Fairbanks Morse & Co.

Model: 8A

[Riders Volume 10 - CHANGES 10-1](#)

Fairbanks-Morse 8A

**New antenna circuit of the Automatic
960 A Series.**

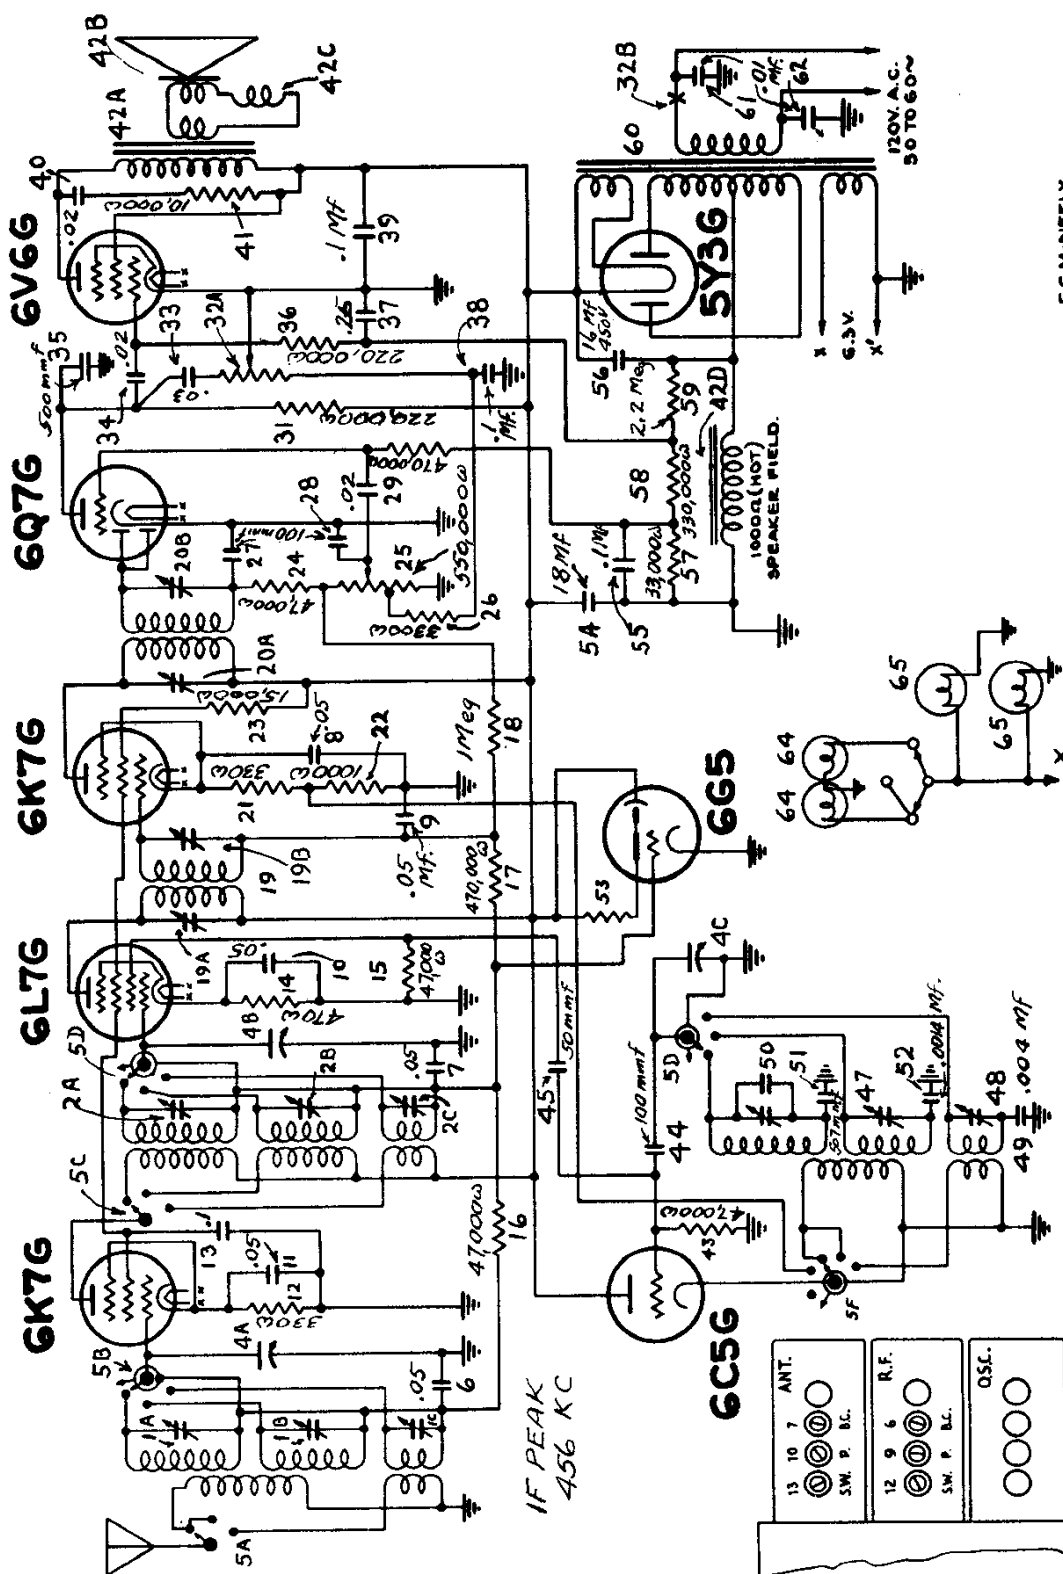
The accompanying partial schematic shows a change which was incorporated in the 960 series, the schematic of which is shown on page 9-2 in *Rider's Volume IX*. Note also that the receivers in which this change has been made have an i-f peak of 480 kc, instead of 456 kc and that they are identified by the letter "A" after the model number.
